### ADDENDUM NO. 1 TO THE DRAWINGS, SPECIFICATIONS AND CONTRACT DOCUMENTS FOR:

## FAIRFIELD COUNTY 2025 PARKING LOT IMPROVEMENT PROJECT 239 East Main Street Lancaster, Ohio 43130

FULL DEPTH PAVEMENT REPAIR N.T.S.

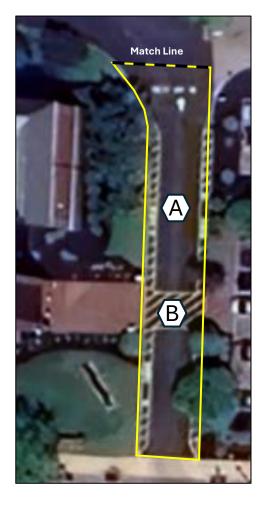
2. Addition of .5" Leveling Course (See Plans Page 2 of 3, ATTACHED)

FOR THOSE AREAS DESIGNATED TO RECEIVE ASPHALT RESURFACING, THE CONTRACTOR SHALL GRIND AND REMOVE THE EXISTING SURFACE COURSE ENSURING ADEQUATE PENETRATION OF THE MILL HEAD INTO THE INTERMEDIATE COURSE. CONTRACTOR WILL PLACE A MINIMUM OF 1.5 INCHES AS INDICATED ON THE PLANS OF ODOT 441 TYPE I ASPHALT. THE ASPHALT MAY BE PERFORMED WITH A ½ INCH LEVELING COURSE AND THEN A 1.5" INCH FINAL COURSE. THE COST FOR THE .5" LEVELING COURSE IS TO BE INCLUDED IN ADDENDUM #1.
